## DOCUMENT 009113 – ADDENDA NUMBER 1

- A. Project Name: LPS – Saratoga School Window Replacement Project.
- B. Project Location: 2215 South 13<sup>th</sup> Street, Lincoln Nebraska.
- C. Owner: Lincoln Public Schools.
- D. Owner Project Number: Bid Number 7683.
- E. Architect: Clark Architects Collaborative.
- F. Date of Addendum: April 10, 2014.

AAD-1.0  
Addendum No.1

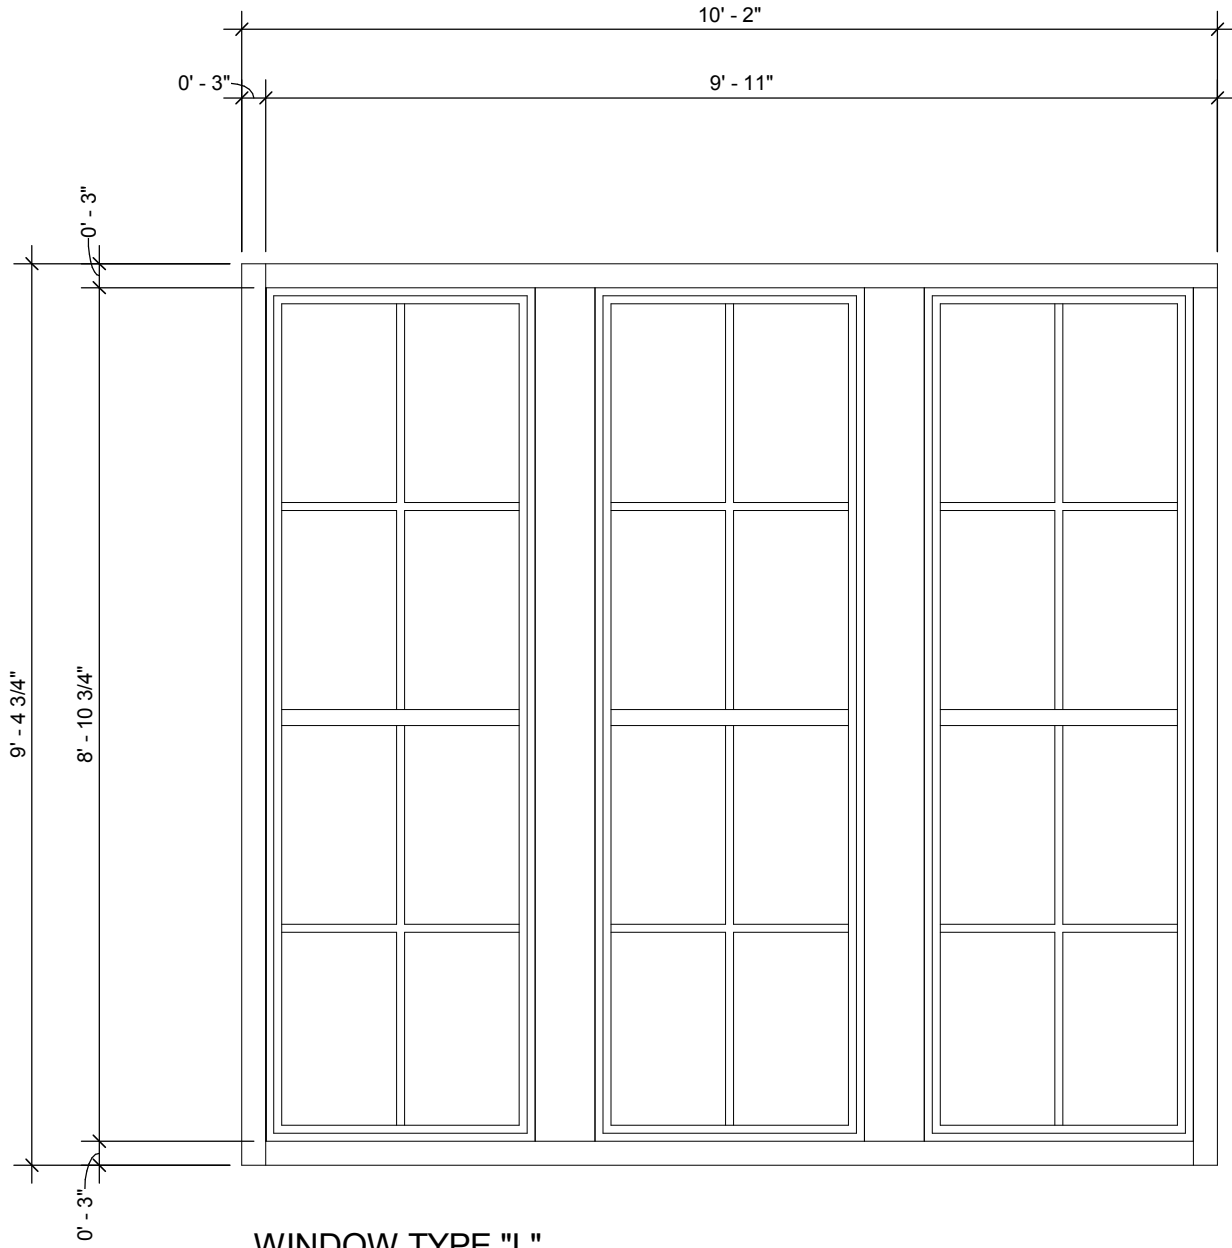
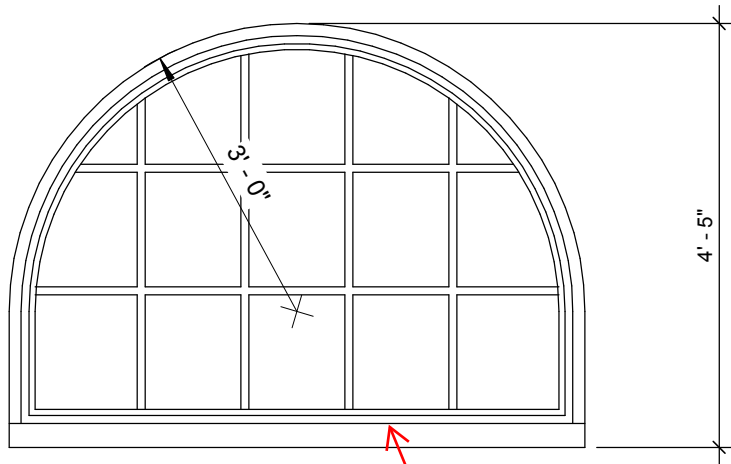
- 5. Drawing A5 Second Floor Plan North: The window at the north end of the corridor that is noted to “Remain” is to be replaced. The window directly below it (arched) is also to be replaced. See drawing AAD-1 and AAD-2 included with this addendum.

- B. Sheet A107 - Second Floor Plan North RCP (not reissued).
  - 1. Add Window Types “L” and “M” to this sheet. Window L is indicated on AAD-1.0 and Window M is indicated on AAD-2.0.

- 2. A window pocket is to be installed at the head of Window Type L at the north end of the Corridor. See AAD-1.0
- C. Sheet ME1.1 – First Floor Mechanical and Electrical Plan (not reissued).
